STATE OF MAINE
DEPARTMENT OF TRANSPORTATION
16 STATE HOUSE STATION
AUGUSTA, MAINE
04333-0016

February 19, 2010
Subject: **Boothbay**
State Pin No: 012630.00
Amendment No. 4

Make the following changes to the Bid Documents:

SECTION A

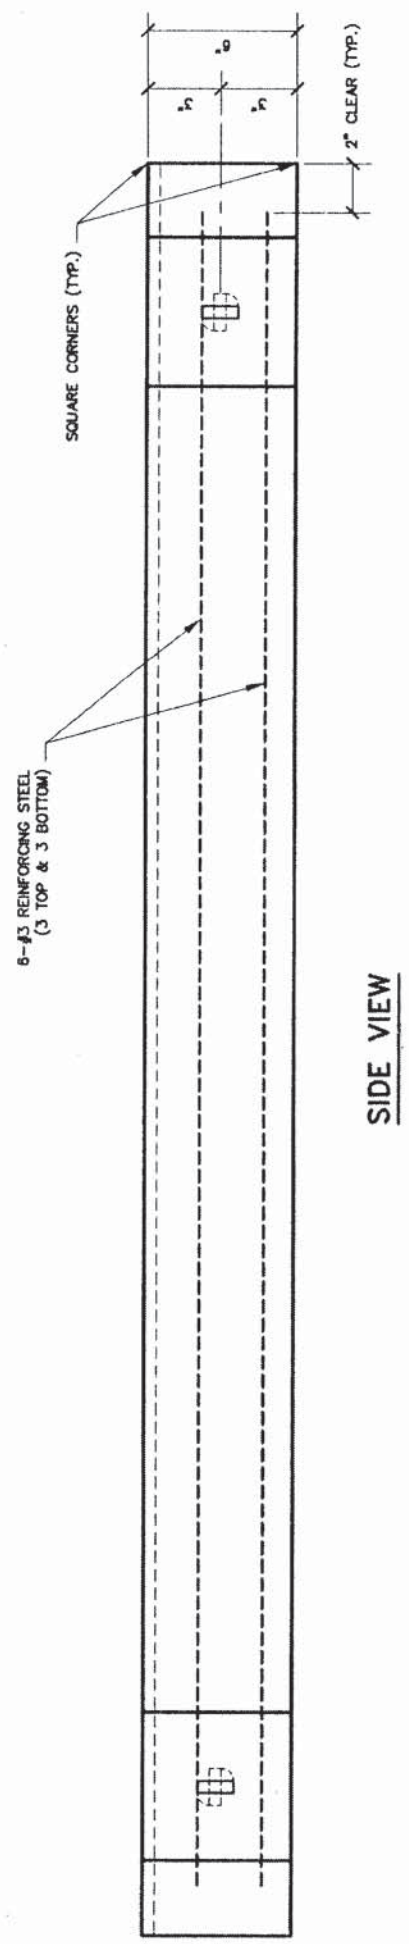
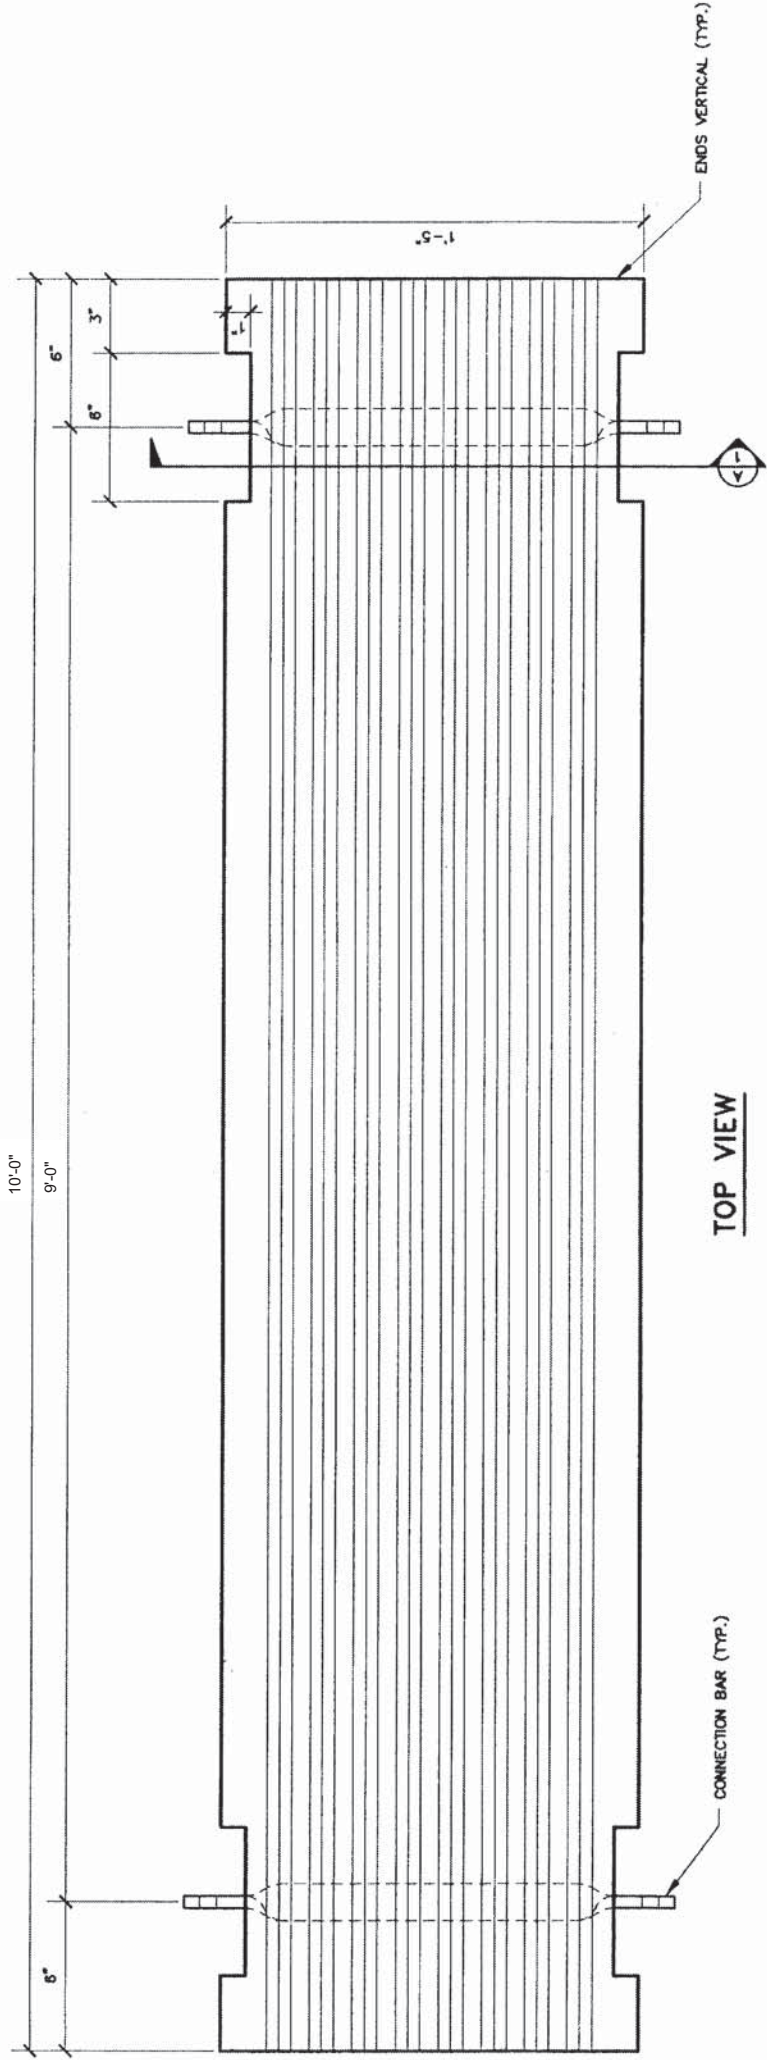
In the Bid Book, “SPECIAL PROVISION, SECTION 853, Boat Ramp”, after page 175, **ADD** the attached 2 details.

Question: Is the Contractor or DOC supplying the boat ramp planks? If it is the Contractor, could you please provide details for the planks, quantity, QC requirements, etc.?

Response: The Contractor is supplying the planks. Please see the attached details. The number of planks is included in the schedule of items. Also see special provision Section 853 Boat Ramp.

OVERHANG BRACKET

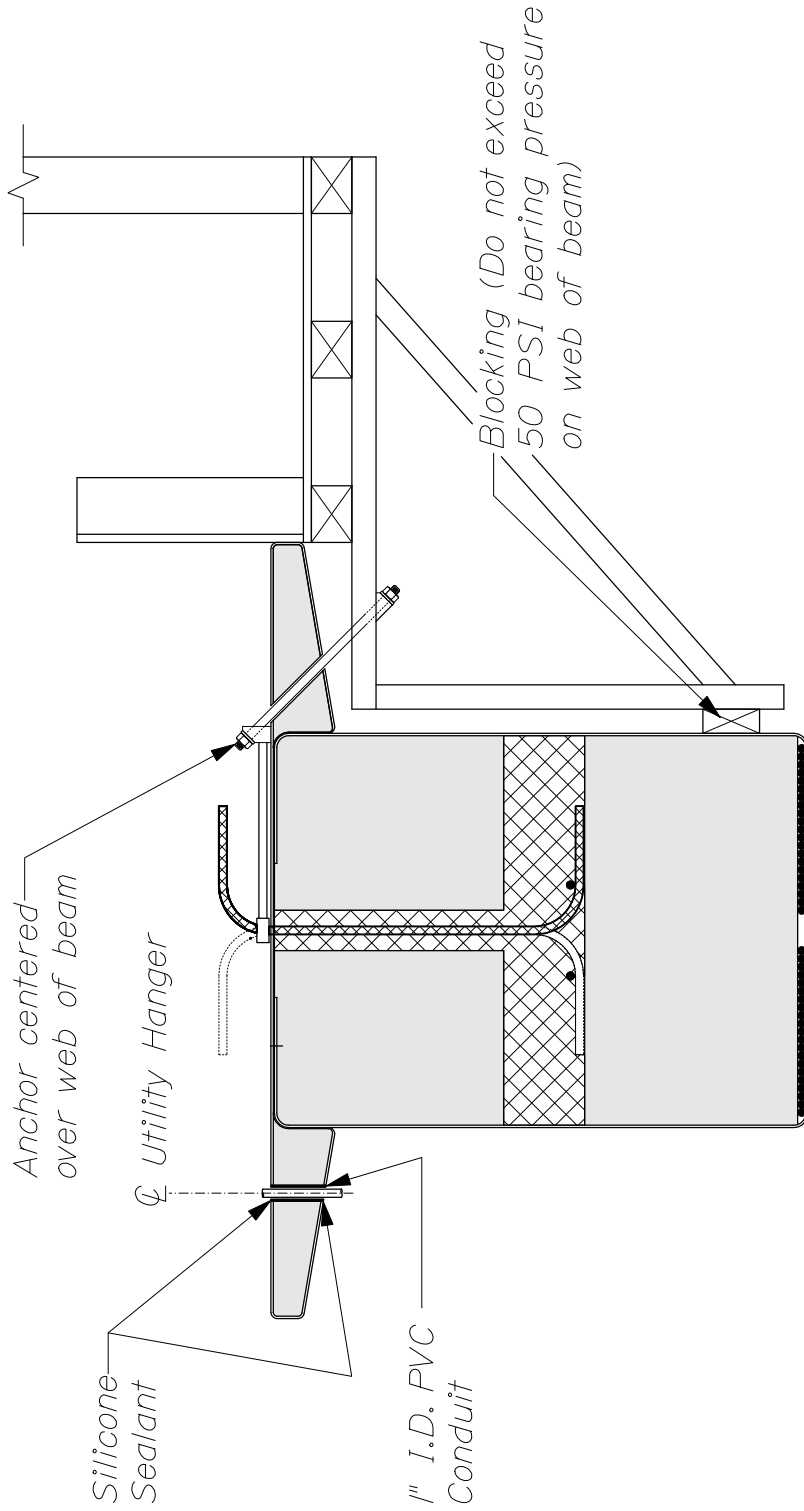
In the Plans, SHEET NUMBER 41 OF 51 (SUPERSTRUCTURE DETAILS), **ADD** the following note in pen and ink;
“5. To install the utility bracket, for each threaded rod that goes through the HC Beam flange, the Contractor shall drill holes through beam flanges, install 1” I.D. PVC electrical conduit, and seal with a silicon sealant around the perimeter of conduit on both the top and bottom side of the flange. Payment shall be incidental to item 890.01 Special Work Number 1 (Utility Conduit Installation).” See attached detail titled “Overhang Bracket”.

Question: What loads can the flange of the beam support?

Response: To support the overhang brackets, the beam designer, John Hillman, suggests using a 45 degree tie that is attached to a shear connector or a simple vertical anchor cast in the web. Please see the attached detail. The hole in the HCB flange extension would be centered about 1-1/2" to 2" away from the face of the web. This would put the beam hanger bearing almost directly on top of the HCB laminate webs themselves. This is a similar detail that was used for the High Road Bridge in Illinois and provided a stable bearing location to prevent any localized crushing of the foam and mitigate any additional cantilever moments in the flange overhang. After removing the steel tension ties, the holes in the flange overhangs are to be completely filled with a closed-cell, expandable polyurethane foam. Once the foam has cured, it shall be struck off flush with the bottom of the flange. The remaining exposed foam shall be sealed by adhering a rectangular plate of FRP, approximately 3"x4"x1/8" thick using one of the two part methylmethacrylate adhesives approved for fabrication of the HCB units.
